City of Madison

Planning Commission Report

Agenda Item: *Ashbury Subdivision, Phase 3*
Request: Preliminary Plat Approval
Applicant: Breland Homes, Inc.
Owner: Breland Homes, Inc.
Engineer of Record: Jennifer Trice, PE, Trice Engineering
Surveyor of Record: Gerald Martin, PLS, Gerald Martin Surveys, Inc.

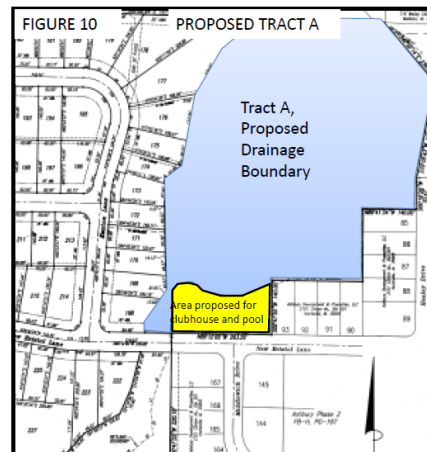
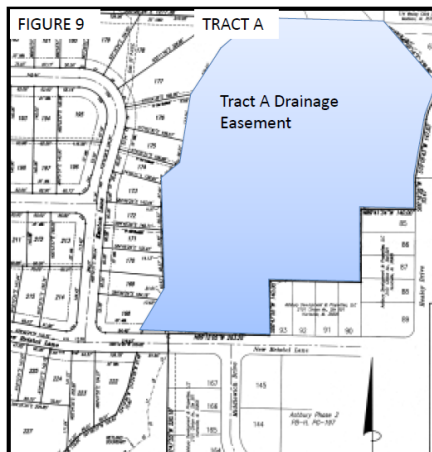
The applicant is requesting modification of a planned drainage easement which overlays Tract A in its entirety.

The purpose of the modification is to provide a location for a clubhouse and pool on a portion of Tract A.

The applicant submitted an engineering change order revising the approved construction plans. The engineering change order recommends changes to the grading and drainage plan that will allow the planned drainage easement to be removed from the portion of Tract A in which the proposed clubhouse and pool are to be located.

Figure 11 provides an up-close look at the area of Tract A in which the applicant is requesting modification to the planned drainage easement. The area highlighted in green is designated a regulatory wetland.

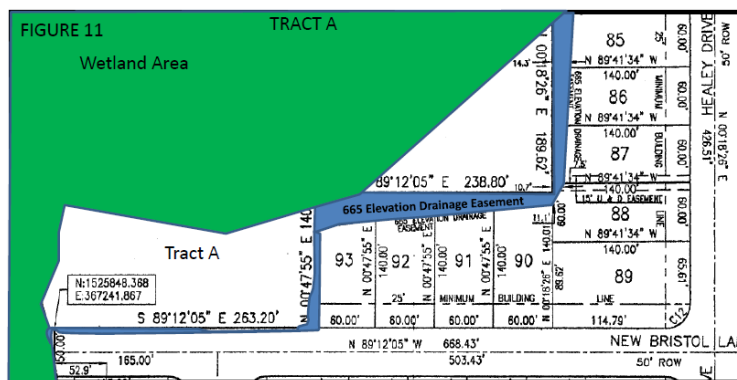
The area in which the applicant is requesting the planned drainage easement to be moved for the purpose of locating a clubhouse and pool, is not designated a regularly wetland.
